Access Compliance Report

Public Rights-of-Way

(Pedestrian Signals)

Intersection ID: N/A	Main Street:	Cross Street: N/A	Location: N/A
ADA ID: E00BC606DA76	Signal Type: One Push Button-Non APS	Overall Compliance: No	Severity Score: BTN 1: N/A BTN 2: N/A No BTN: N/A
Codes/Mitigation Info/Possible Solution		Field Measurements/Component Compliance

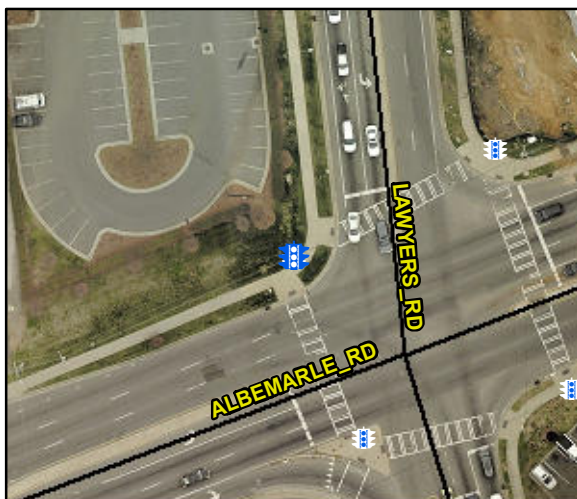
Surveyor Notes: TEXT HT 7/16

PROW/ADA: R410.6, TMUTCD 4e.08, R404.2, R404.3, R406.2, R404.7.3

Possible Solutions: Replace Signal Push Button With APS Button on New Post. Remove & Replace Sign.
